Office Action Summary	Application No. 10/563,338	Applicant(s) LAGLER, LOUIS	
	Examiner ANDREW T. KIRSCH	Art Unit 3781

DETAILED ACTION

8. Claim 1 is rejected under 35 U.S.C. 103(a) as being unpatentable over US Patent No. 5,148,912 (Nozawa hereinafter) in view of U.S. Patent No. 6,460,712 (Smith et al. hereinafter).

Fig. 1 of US Patent No. 5,148,912 (Nozawa hereinafter)

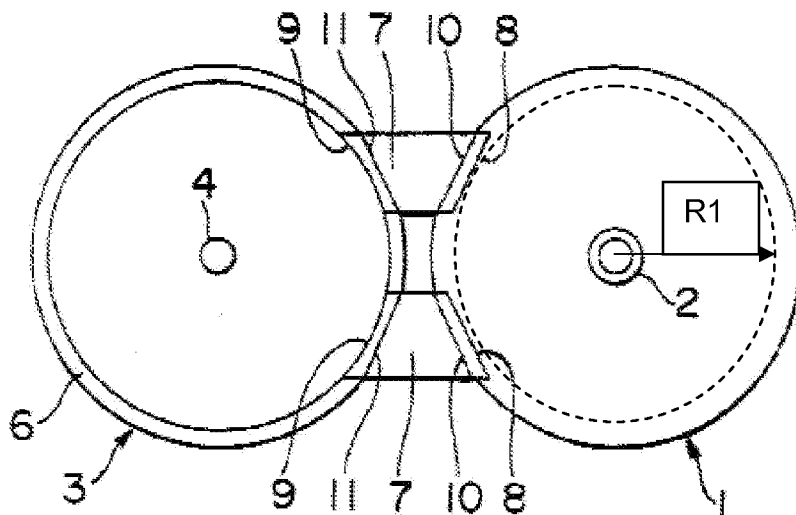
9. In re Claim 1, with reference to Fig. 1 and Fig. 4 above, Nozawa discloses: A closure moulded in closed position with

- a ring shaped body (see Fig. 2), the ring shaped body having an opening (see Fig. 2) extending in an axial direction and having substantially the same diameter at

both ends (see Fig. 2), comprising fixing (col. 7, lines 5-7) means to fix the closure on a neck of a bottle, and

- a lid (3), the lid having substantially the same diameter as the ring shaped body (see fig. 3) and positioned immediately adjacent to the opening at a top open end of the ring shaped body when the lid is in the closed position, the lid comprising a sealing means (4) to seal an orifice (2) of the bottle, whereby the body (see ring shaped body) and the lid (3) are separated to [from] each other by a circumferential gap (see Fig. 2).

- a snap hinge comprising a first and a second trapezoid element (7) and a first and second pair of film hinges (10, 11) each pair defining a first and a second plane (Fig. 4), the first and the second pair of film hinges (10, 11) connecting the first and the second trapezoid element (7) to the lid (3) and to the body (1), whereby the first and the second plane are arranged substantially parallel to an axis A (Fig. 4) of the closure.

19. In re claim 4, with reference to the Figs. above, Nozawa in view of Smith et al. and Rentsch disclose the claimed invention including wherein the film hinges (10, 11) and the inner periphery of the closure are designed such that they do not protrude over a main inner radius (R1) of the closure (see fig. 1) (the largest inner radius would be from the center of the closure to groove 8, which stores the hinge and therefore would not protrude over the radius).

FIG.2

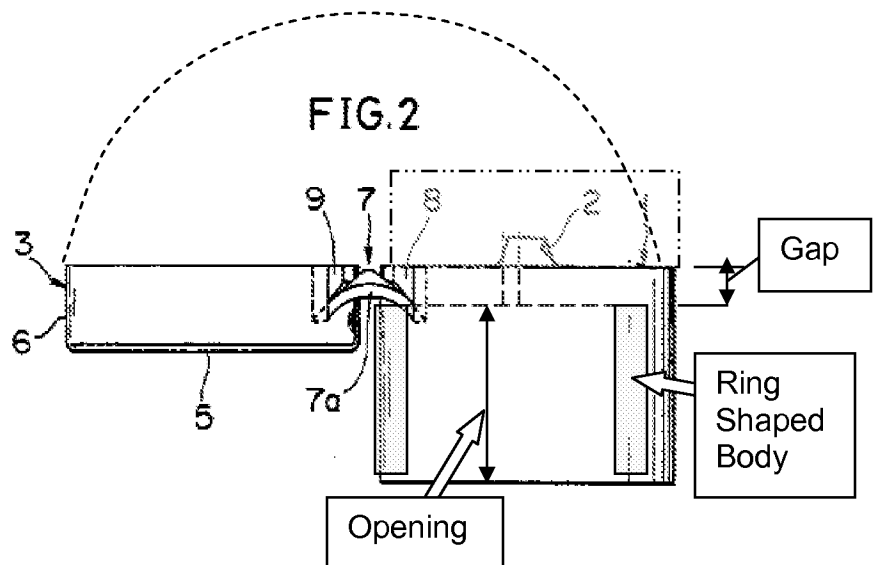
10. Note that the opening (2) could also be considered a "circumferential gap" because it is a gap having a circumference, and is between the lid and the body (ring shaped body).

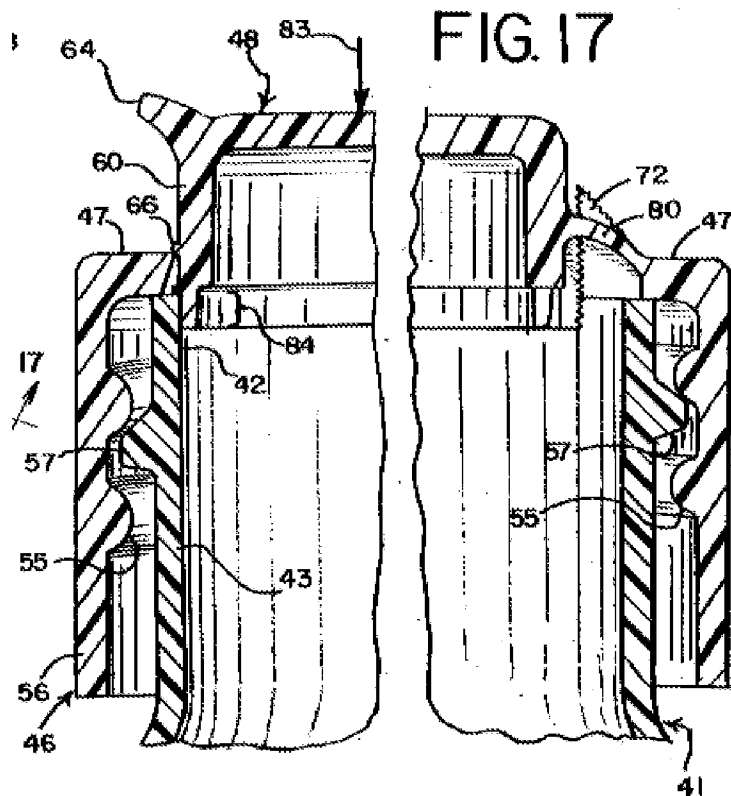
12. However, with reference to Fig. 17 below, Smith et al. discloses a closure wherein a sealing member (84) not only seals an orifice (42) of a bottle and the orifice of the body (47, at 66), but also directly contacts the neck (43) of the bottle to better seal the sealing means to the bottle.

Fig. 7 of Rentsch et al.

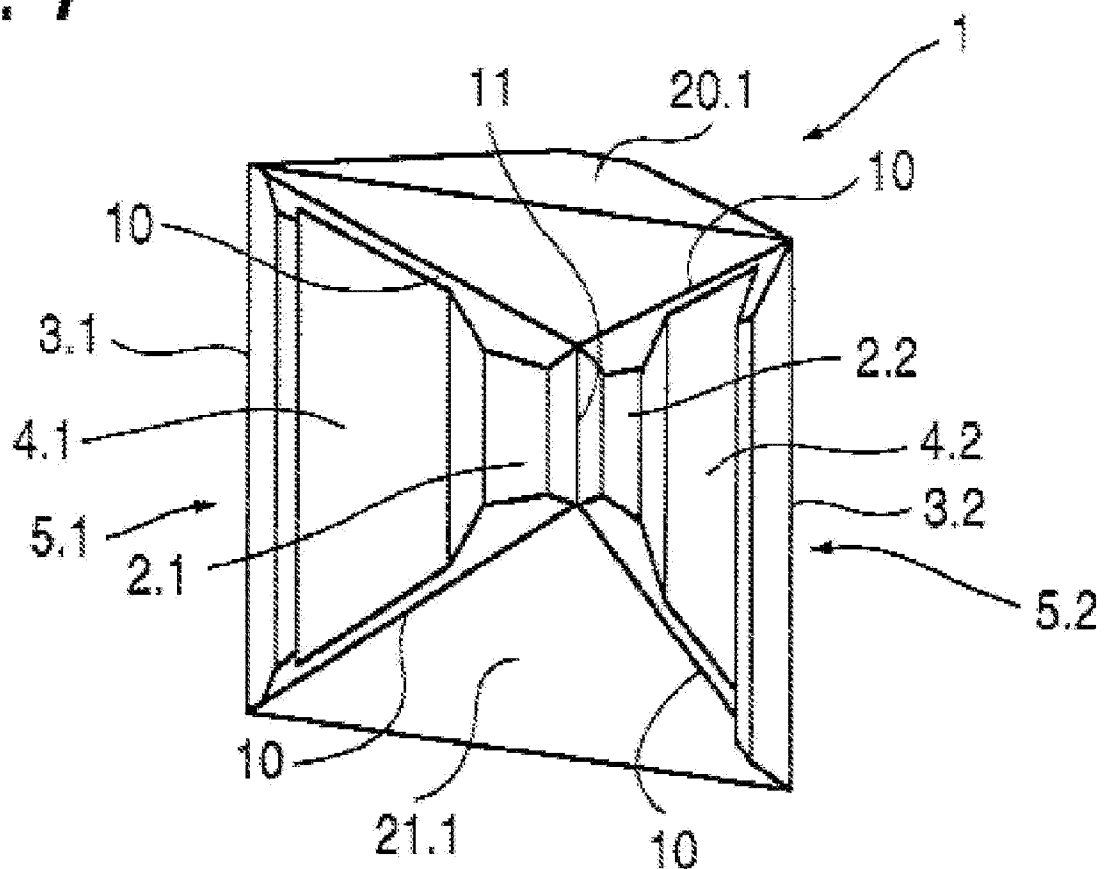
22. In re Claim 7, with reference to Fig. 7 above, Rentsch et al. discloses that the trapezoid elements (5.1, 5.2) are connected by a thin film hinge along a shorter edge (11).

FIG.6

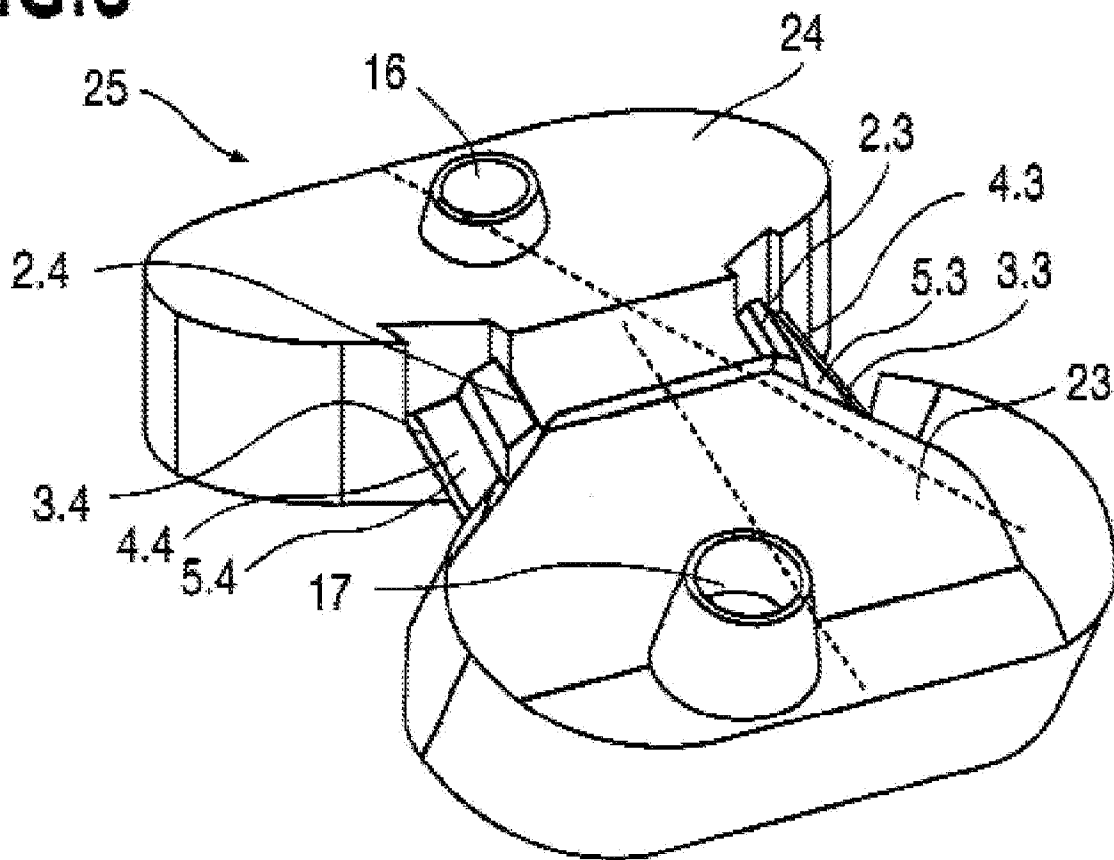
23. In re Claim 9, with reference to Fig. 6 above, Rentsch et al. discloses that the body (24) and lid (23) are in the open position spaced a distance s apart, whereby distance s is equal to 50% to 90% of the shorter edge of the trapezoid element (5.4, 5.3). In order for s to be 50% to 90% of the shorter edge of the trapezoid α must be between 120° and 154° or between 206° and 240° . Rentsch et al. discloses that the

closure is capable of angles greater than 180°. Thus, the closure disclosed by Rentsch et al. can be in either range of angles when in the open position.

Fig. 3 of US Patent Application Publication No. 2002/0079282A1 (Harrold et al. hereinafter)

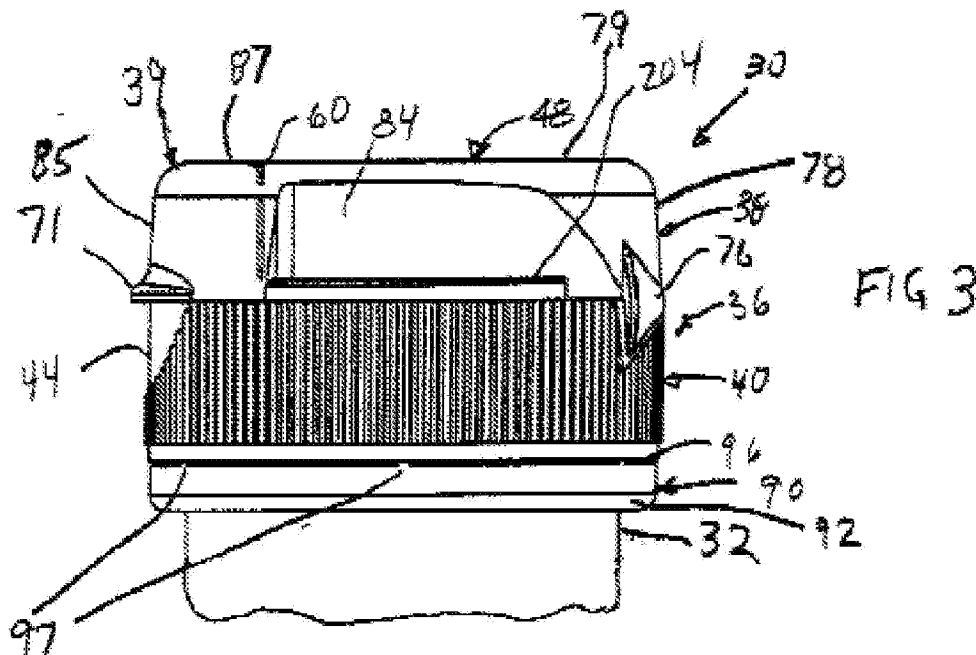
28. However, with reference to Fig. 3 above, Harrold et al. discloses tamper evidence means (90).

29. Thus, it would have been obvious to one having ordinary skill in the pertinent art at the time the invention was made to have modified the closure disclosed by Nozawa in

view of Rentsch et al. to have tamper evidence means as taught by Harrold et al. in order to achieve the predictable result of indicating if the closure had been tampered with.
